LCB500-12W-6 Copper Lug - One-Hole, Long Barrel with Window

LCB500-12W-6

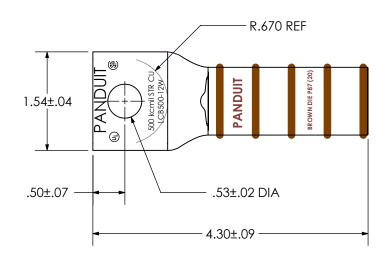
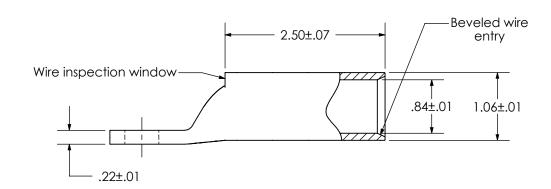
REV	DATE	BY	СНК	DESCRIPTION	ECN	S
00	5/16	JHNU	JHNU	DRAWING RELEASED		
01	11/16	JHNU	JHNU	REVISED HOLE OFFSET & BARREL LENGTH TOLERANCE: ±.07 WAS ±.04 REVISED OVERALL LENGTH TOLERANCE: ±.09 WAS ±.06 REVISED WIRE STRIP LENGTH: 2-5/8 WAS 2-9/16	00127LBS- LCB500-12W-CUST	
02	, .,				LCB300-12W-C031	
02	12/17	JHNU	JHNU	REVISED WIRE STRIP LENGTH: 2-9/16 WAS 2-5/8	00127LBS- LCB500-12W-CUST
